European Union Aviation Safety Agency  
**Comment-Response Document 2019-09**

RELATED NPA: 2019-09 — RMT.0379 — 3.8.2021

Figure 2: Vertical profile

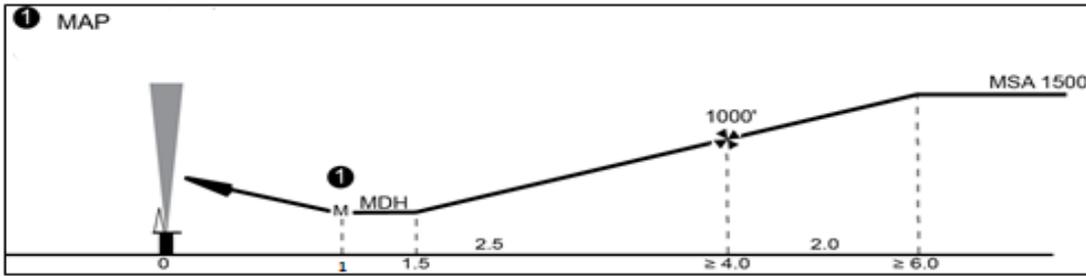
Figure 2: Vertical profile must be edited to match the procedure description.  
Mapt is at 1 NM  
There is no OIP

Figure 2: Vertical profile must be edited to match the procedure description.  
Mapt is at 1 NM.  
There is no OIP.
